Marin County Flood Control and Water
Conservation District
**Corte Madera Creek Flood Risk Management
Project, Phase 1**
Final Environmental Impact Report
Volume 1: Comments and Responses to Comments
State Clearinghouse No. 2020080353

**Marin County Flood Control and Water
Conservation District
Corte Madera Creek Flood Risk Management
Project, Phase 1
Final Environmental Impact Report
Volume 1: Comments and Responses to Comments
State Clearinghouse No. 2020080353**

Figure 3.13-1 Local Transportation Network

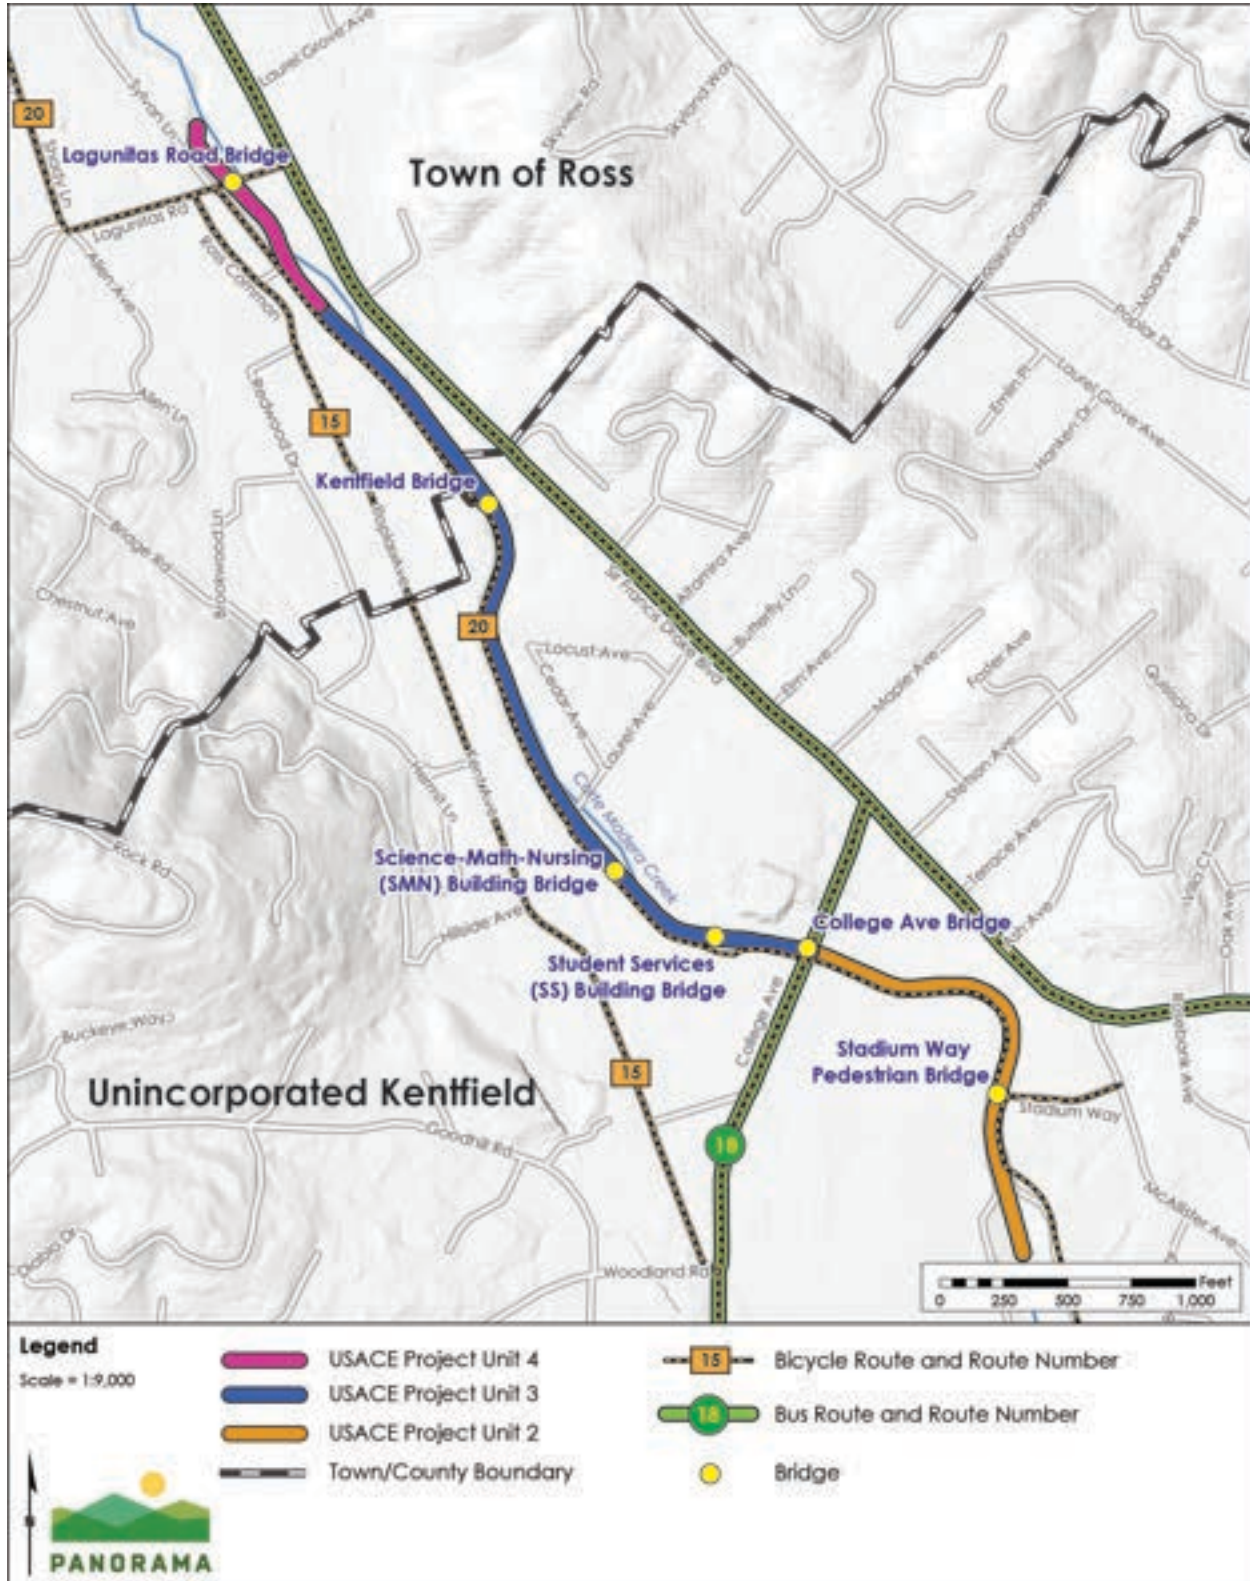
Figure 3-13-1 Unnamed Path #3 is mapped as a bicycle route. It is virtually never used by cyclists and the Marin County Bicycle Coalition does not consider it a bicycle route.

- B1-45 The commenter states that in Figure 3.13-1 in the Draft EIR, Unnamed Path #3 is mapped as a bicycle route.

Figure 3.13-1 has been revised as follows in the Draft EIR to remove the bike route from the right bank of the creek south of Stadium Way.

Figure 3.15-1 Utilities and Service Systems in the Project Area (Map 1 of 3)

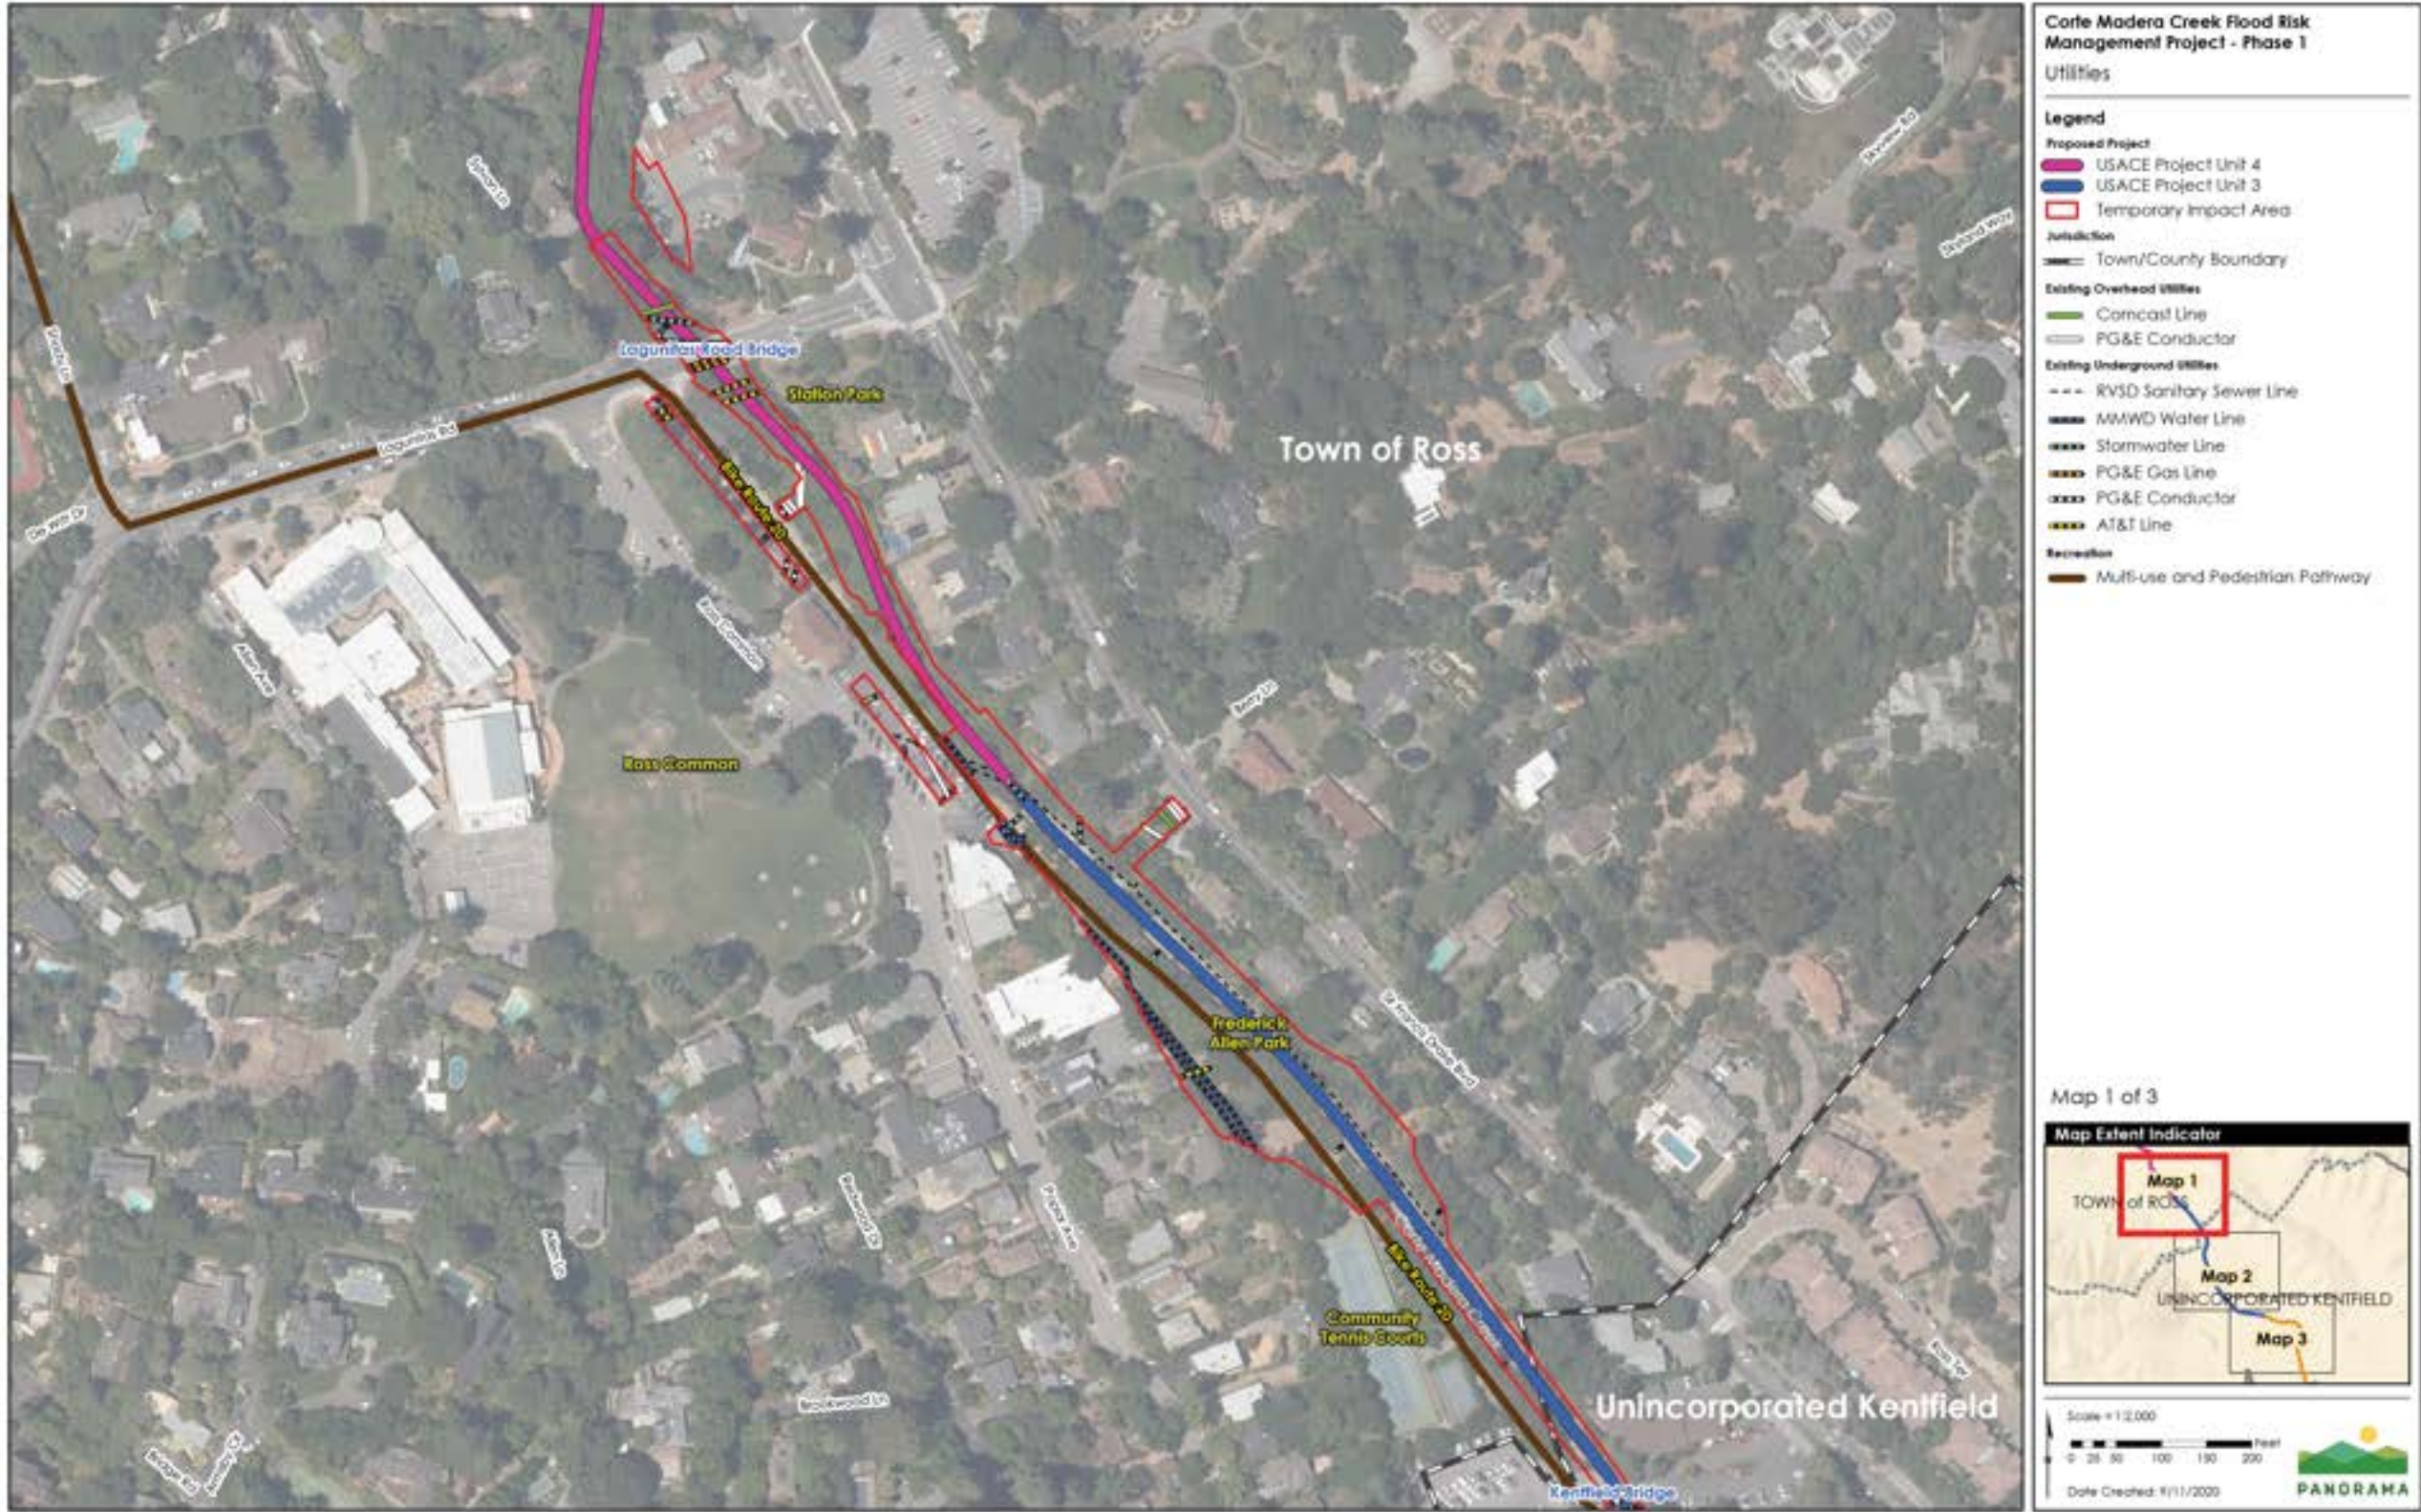
The first full paragraph on page 3.15-2 states: "An aboveground sewer pipe crosses the creek on the pedestrian bridge at the end of Stadium Way (Figure 3.15-3)." The sewer is a deeply buried pipeline that crosses the creek in an inverted siphon. The aboveground pipeline is a water distribution line.

The legend refers to MMWD stormwater lines. This is inaccurate: MMWD supplies treated domestic water; towns and the District are responsible for stormwater. The Design Basis Report (GDG 2020) describes utilities in the Lower COM project area, most of which are not shown accurately on Figure 3.15-3. Also, the outline of the Lower COM project area is inaccurate. It shows two areas that should be removed from the figure: the inaccurate staging area and an area on the left bank that has since removed from the project. Please use the most recent 65% designs.

Figures 3.15-1, 3.15-2, and 3.15-3 in the Draft EIR have been revised as follows (on the next pages) to reflect the utilities and project components as shown in the Basis of Design Report for the Lower College of Marin area.

Figure 2.5-3 Project Elements (Map 3 of 3)

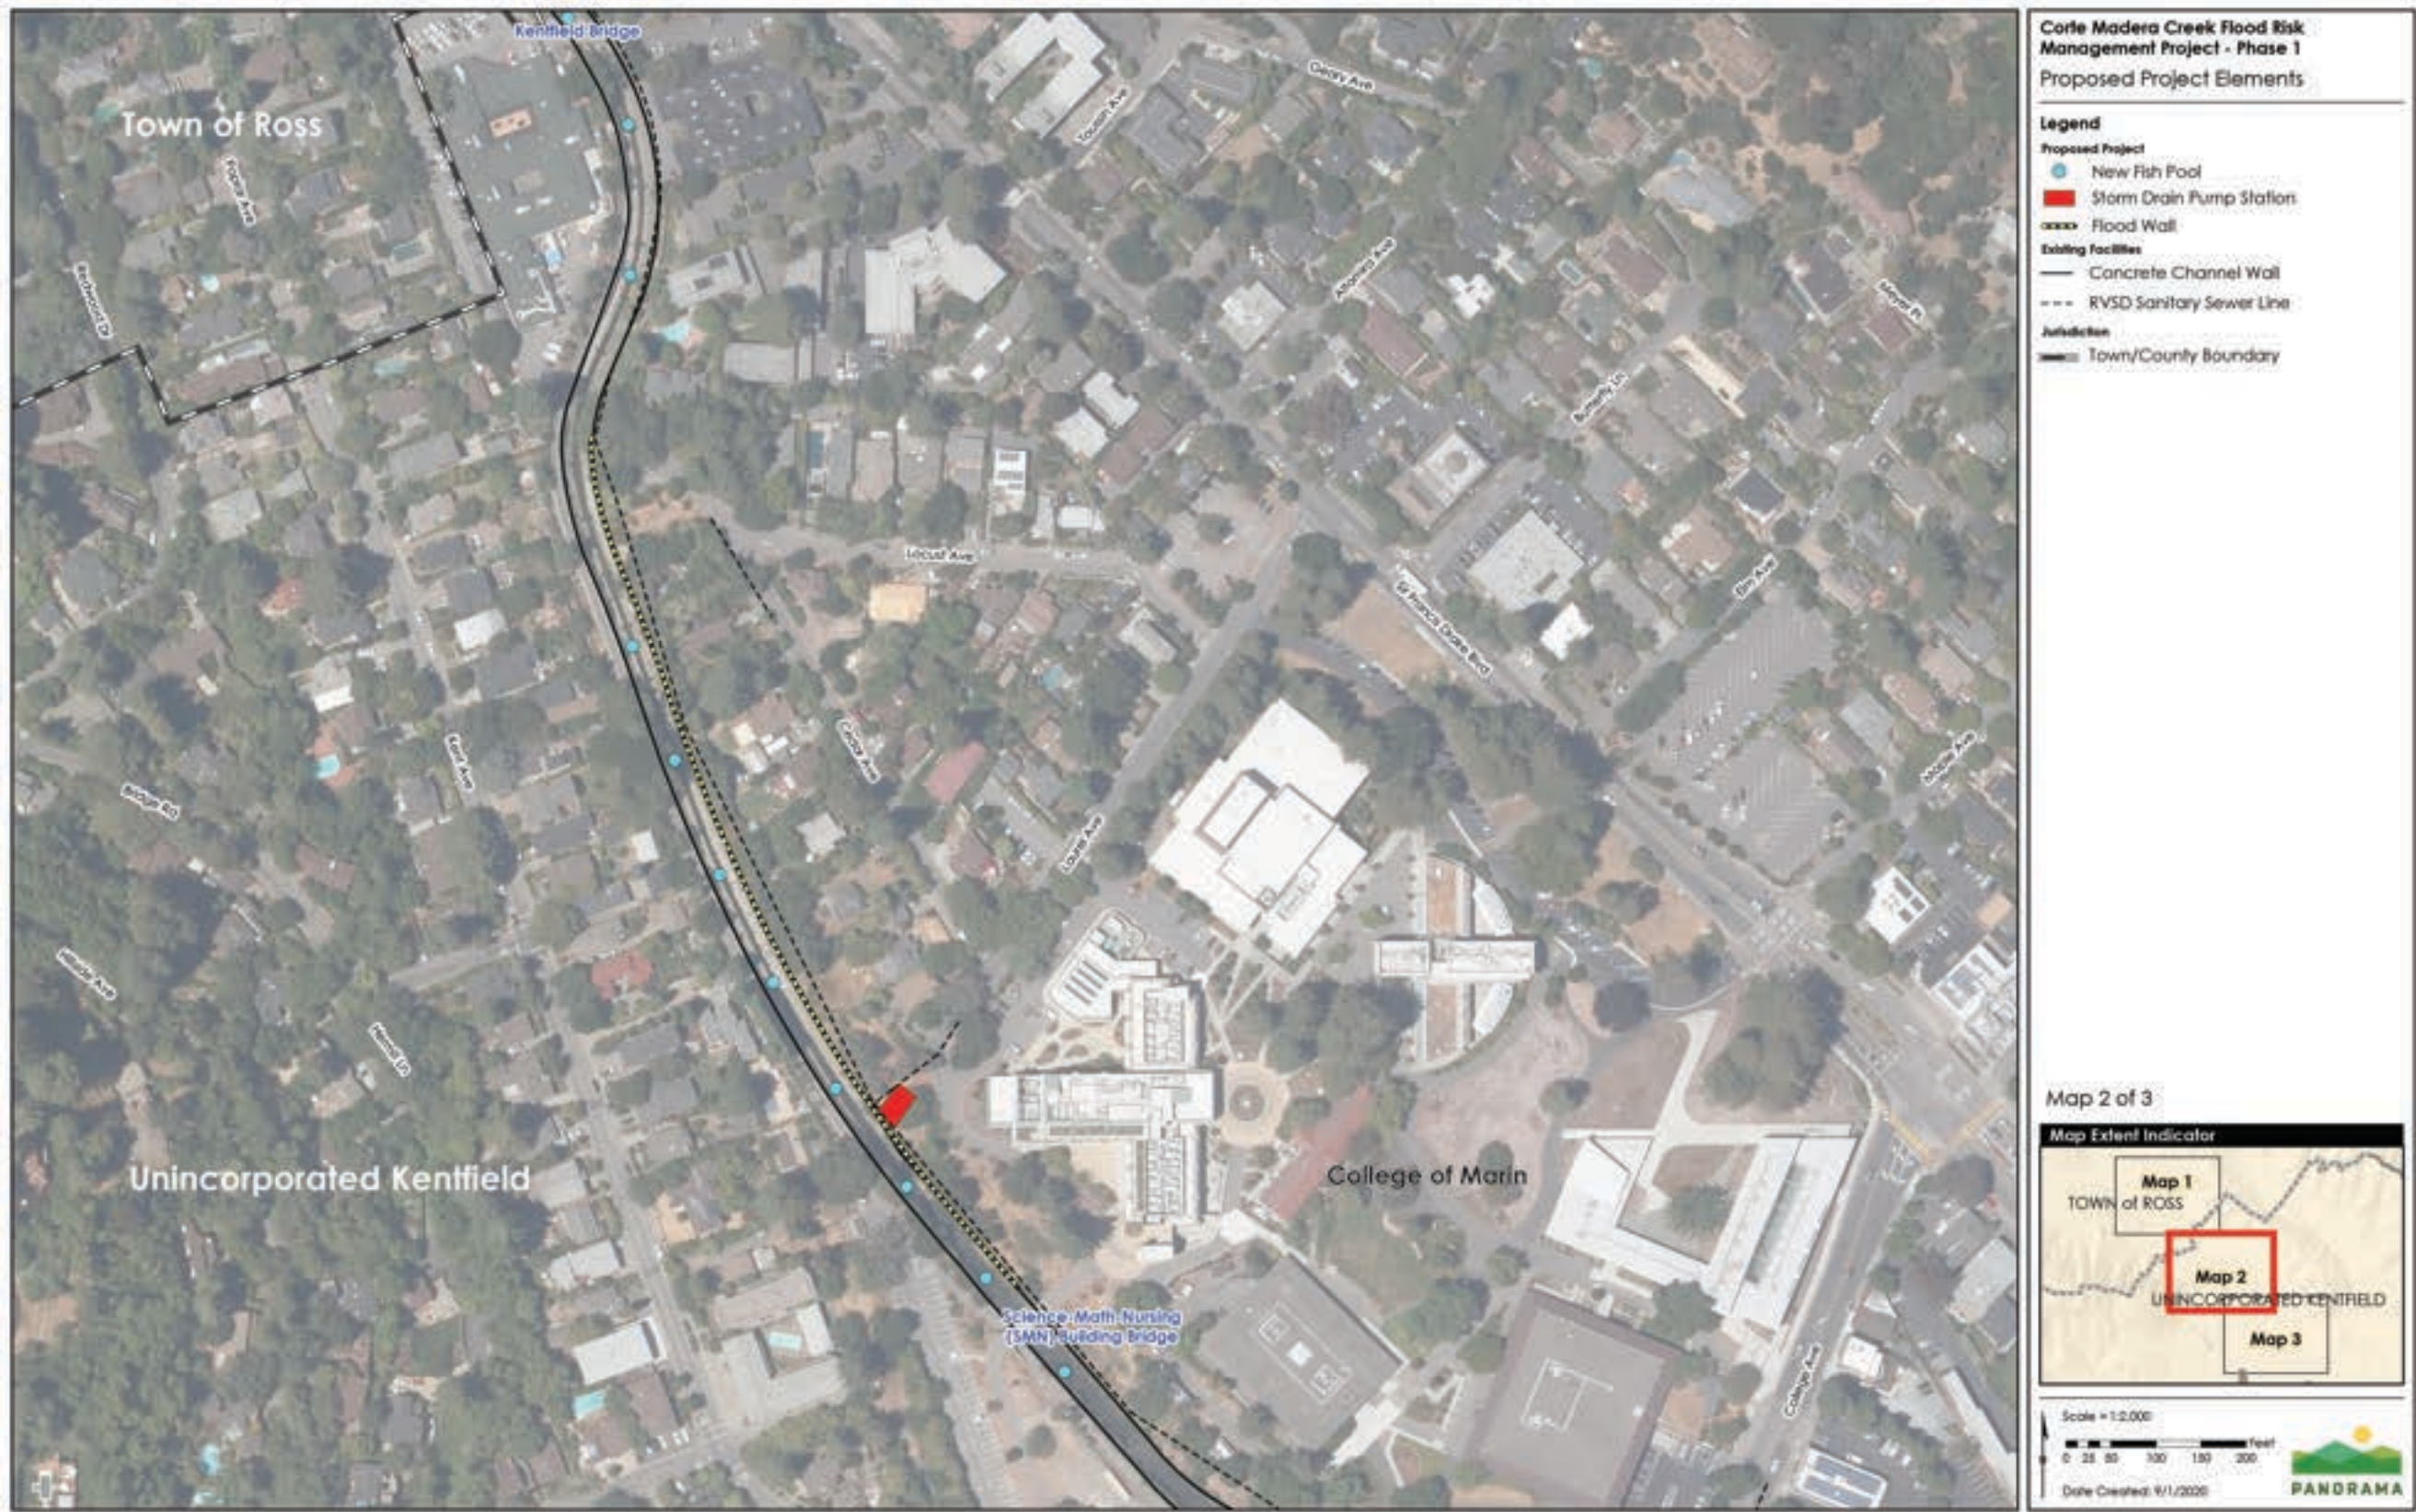
- On page 2-17 figure 2.5-4 should clearly show the existing concrete channel walls on both sides of the channel for ease of reference. A5-8
- On page 2-34 under the section 2.6.4 Grading, the concrete apron at the transition between Unit 3 and Unit 4 should be mentioned and described. A5-9

In response to comment A5-8, Figures 2.5-1 to 2.5-3 in the Draft EIR (pages 2-9 to 2-11) have been revised as follows to show the existing concrete channel walls on both sides of the channel:
